DUKE POWER COMPANY  
CONSTRUCTION DEPARTMENT  
PROJECT Catawba

## RANDOM INSPECTION WORKSHEET

FRONT VIEW  
(DOORS REMOVED)  
I.T.E CUB.#2

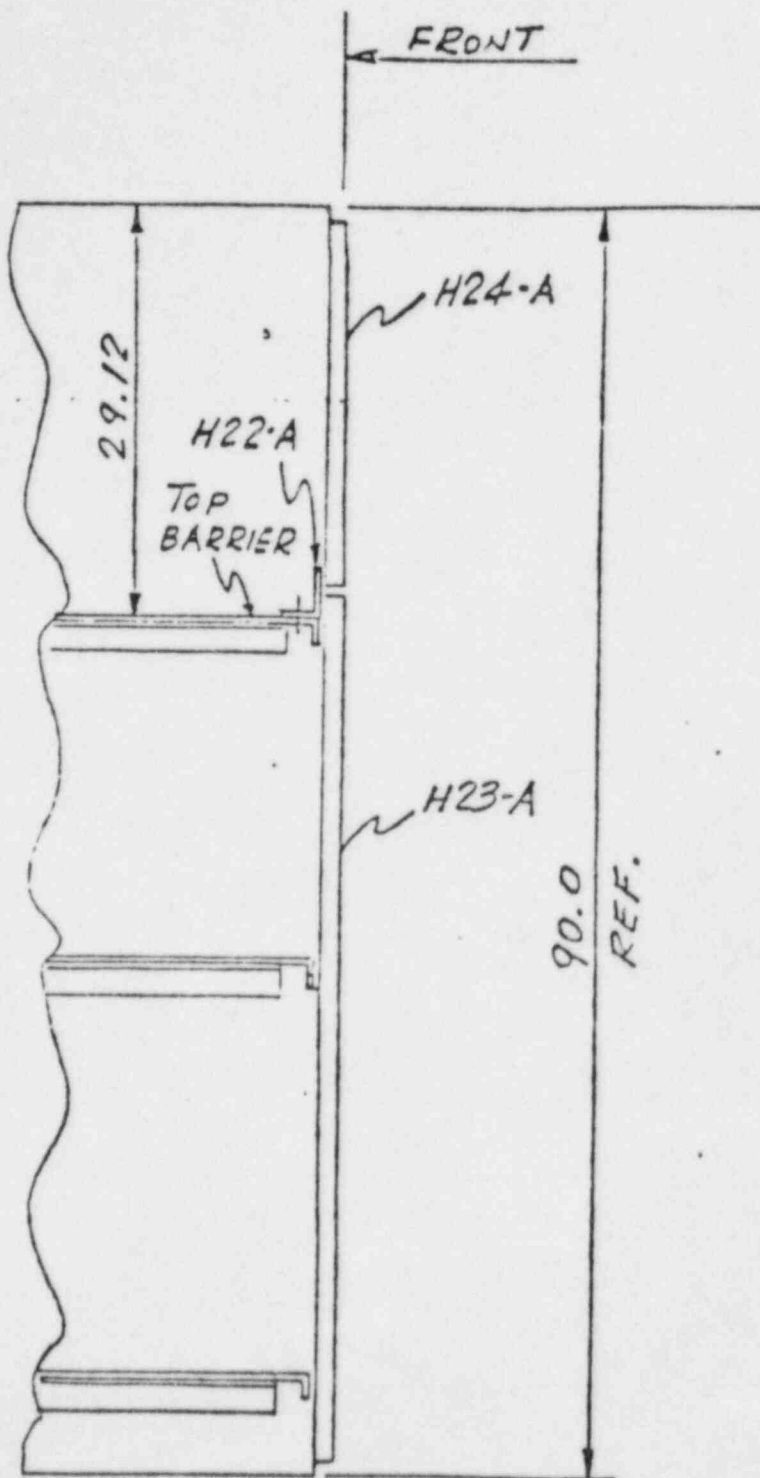
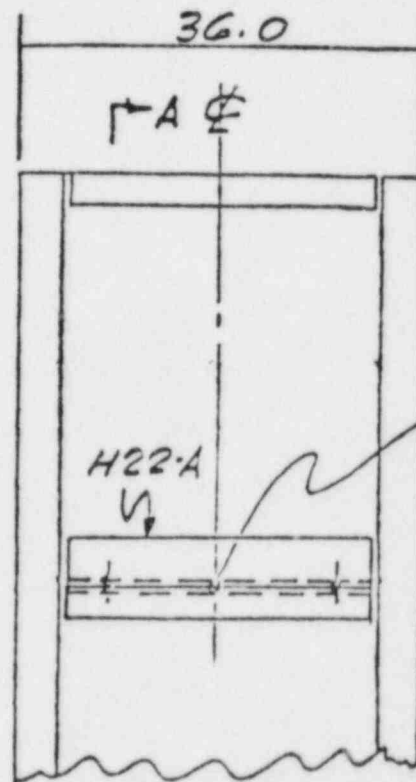
WHEN THE DOOR ON THE POTENTIAL TRANSFORMER COMPARTMENT IS OPENED THE TUBULAR STEEL GRID INTERFERES. THIS WILL PREVENT THE P.T. DRAWER FROM BEING OPENED WITHOUT TAKING OFF THE MAIN DOOR. (SUGGEST USING SPLIT DOORS AS ON THE BREAKER COMPARTMENT)

Because of cable tray interference, you inquired if we could furnish a split front panel to replace the full-high panel on auxiliary cubicle #2 shipped under ITEM A. This has been ordered at NO CHARGE. Supplemental hardware will be furnished for use with existing hardware from cubicle #2.

Could/IE will send a split door for replacement. Delivery date will be assigned later. Refer to the attached letter and drawings upon arrival.
